APPLICATION NO.	FILING DATE	FIRST NAMED INVENTOR	ATTORNEY DOCKET NO.	CONFIRMATION NO.
10/773,215 02/09/2004		Chin-Pei Lin	P05025	6745
40401 7590 03/09/2006 HERSHKOVITZ & ASSOCIATES 1725 I STREET NW, SUITE 300			EXAMINER	
			GARCIA, ERNESTO	
WASHINGTON, DC 20006			ART UNIT	PAPER NUMBER
			3679

Application No.	Applicant(s)				
	10/773,215	LIN, CHIN-PEI				
Office Action Summary	Examiner	Art Unit				
	Ernesto Garcia	3679				
The MAILING DATE of this communication appears on the cover sheet with the correspondence address Period for Reply						
A SHORTENED STATUTORY PERIOD FOR REPLY IS SET TO EXPIRE 3 MONTH(S) OR THIRTY (30) DAYS, WHICHEVER IS LONGER, FROM THE MAILING DATE OF THIS COMMUNICATION. - Extensions of time may be available under the provisions of 37 CFR 1.136(a). In no event, however, may a reply be timely filed after SIX (6) MONTHS from the mailing date of this communication. - If NO period for reply is specified above, the maximum statutory period will apply and will expire SIX (6) MONTHS from the mailing date of this communication. - Failure to reply within the set or extended period for reply will, by statute, cause the application to become ABANDONED (35 U.S.C. § 133).

Attachment: one marked-up page of Desard, 6,368,013

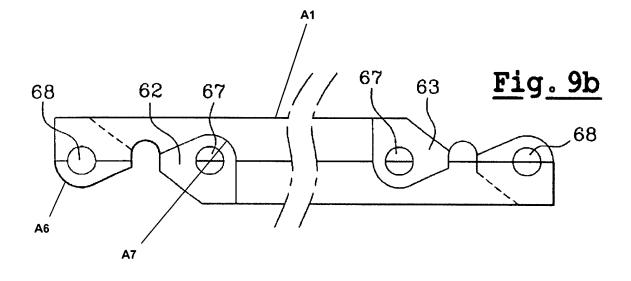
Regarding claim 1, Desard discloses, in Figure 3 and 9b, a do-it-yourself assembly construction piece comprising a body A1 (see marked-up attachment) with multiple ends and a thickness. At least one connecting portion 60,61 extends respectively from the ends of the body A1. The at least one connecting portion 60,61 has a through hole 68, a convex distal edge A6, and a thickness half the thickness of the body A1. The body A1 has a concave face A7 formed concentric with the through hole 68 in each connecting portion 60,61.

Regarding 3, the body **A1** is a bent longitudinal body **A1** with two of the ends, an inner side and an outer side. The connecting portion **60,61** of each of the ends is formed on the outer side (see Figure 3).

Regarding claim 13, the assembly construction piece has the body being a long body **A1** with two of the ends bent in different directions and the ends are parallel to each other.

Regarding claim 4, the body A1 is a bent longitudinal body A1 with two of the ends, an inner side, and an outer side. However, the connecting portion 60,61 of each of the end is not on the inner side, but the outer side. Applicant is reminded that a mere reversal of the essential working parts of a device involves only routine skill in the art; therefore, it would have been obvious to one having ordinary skill in the art at the time the invention was made to place the connecting portions on either the inner side or the outer side as either orientation will allow a connection. *In re Einstein*, 8 USPQ 167.
